DESIGN CHANGES/CLARIFICATIONS – FEB 6, 2014 LETTER TO TCEQ

**Re: Texas Custodial Trust  
Former ASARCO Smelter Site, El Paso, Texas**

**Subject: Construction Status and Design Changes for Cell 3 Cover System**

CELL 3 COVER SYSTEM DETAILS  
 TYPICAL SECTION  
 SCALE: AS NOTED

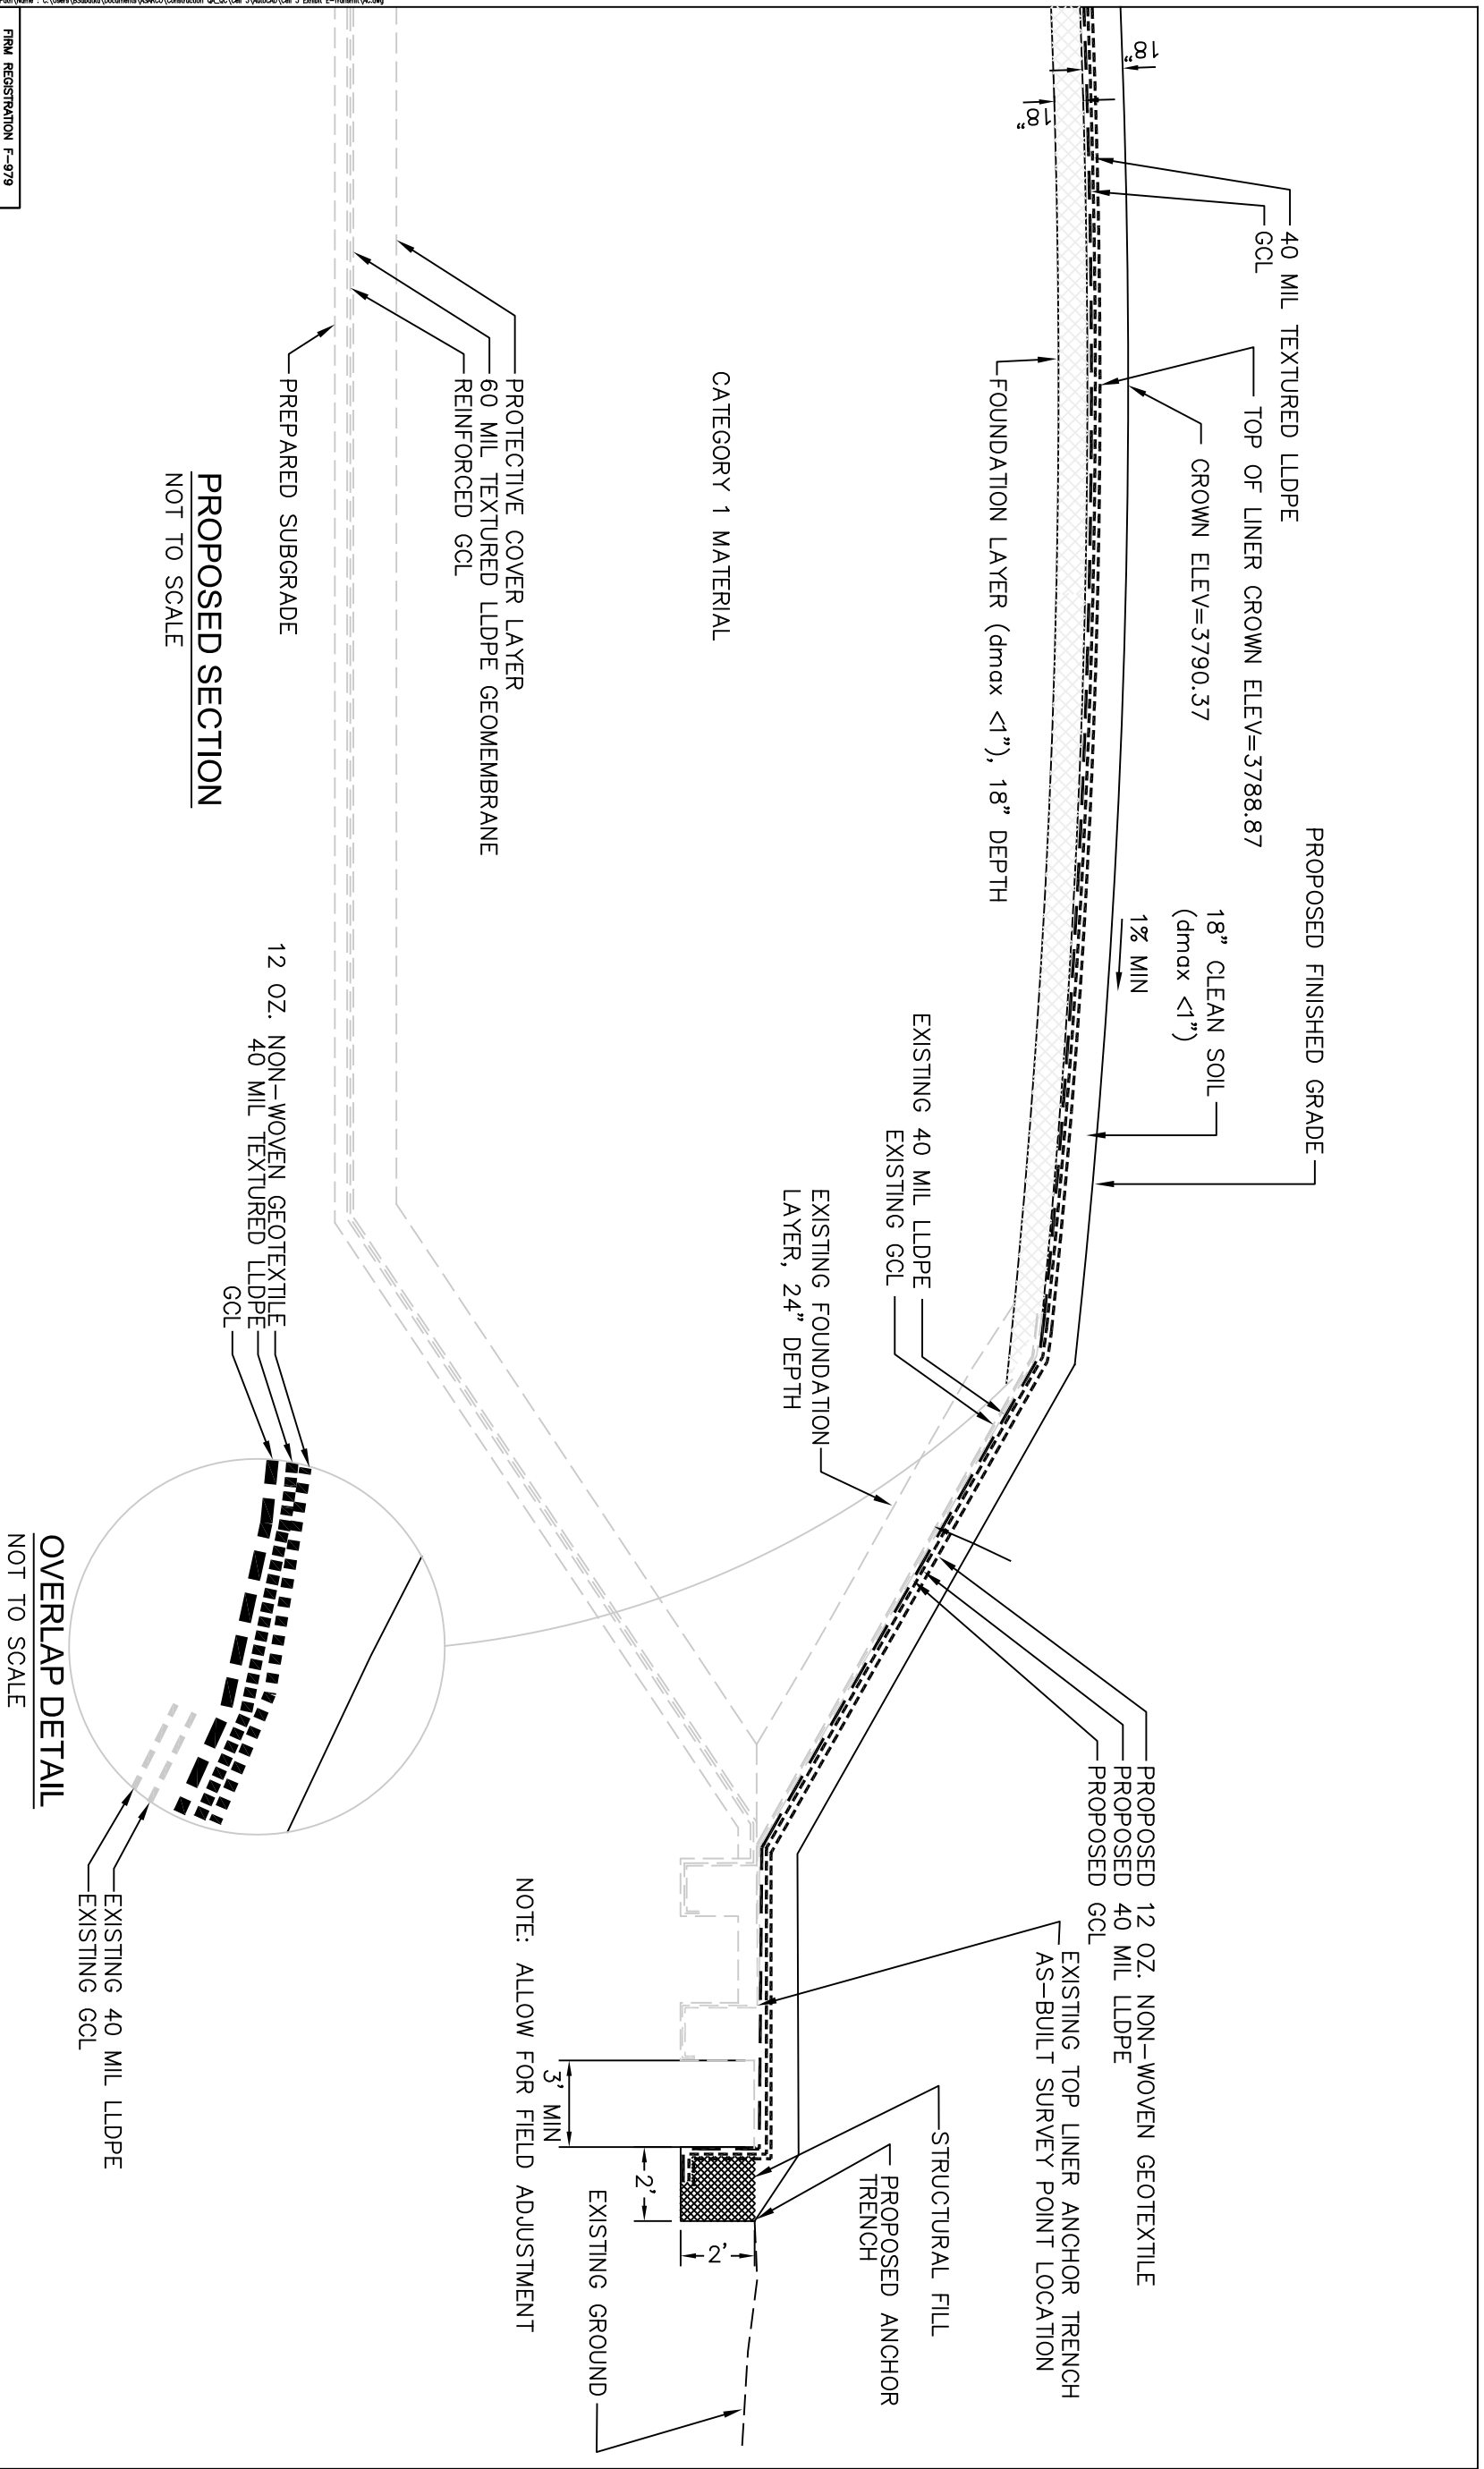
1. The geosynthetic clay liner (GCL) material, Bentomat CLT, specified in Attachment A of the October 10, 2013 letter will be replaced with Bentomat DN. Bentomat DN is the same material as was originally used for the bottom liner of Cell 3. Attachment A includes the specifications for the Bentomat DN.
2. The cover system will extend beyond and below the 3,788 elevation and terminate in a new anchor trench located approximately 3 feet outboard of the existing top liner anchor trench. Details are shown in Sheet 1 in Attachment A. This is needed to extend the new geomembrane beyond the limits of Cell 3 since the condition of the existing geomembrane does not comply with our specifications.
3. The double-sided geocomposite will be replaced with a 12 oz. nonwoven cushion geotextile (see Attachment A for specifications). The reason for replacement of the

geocomposite is because it originally was designed to temporarily convey any infiltrating precipitation to a perimeter drain at the toe of Cell 3. The perimeter drain is no longer needed as part of the overall site drainage system due to future plans for a final soil cover system. Cell 3 will be covered with additional soil preventing infiltration and have other surface drainage components managing runoff in this area. The nonwoven geotextile will cushion and protect the geomembrane liner from potential damage during installation of the clean soil cover.
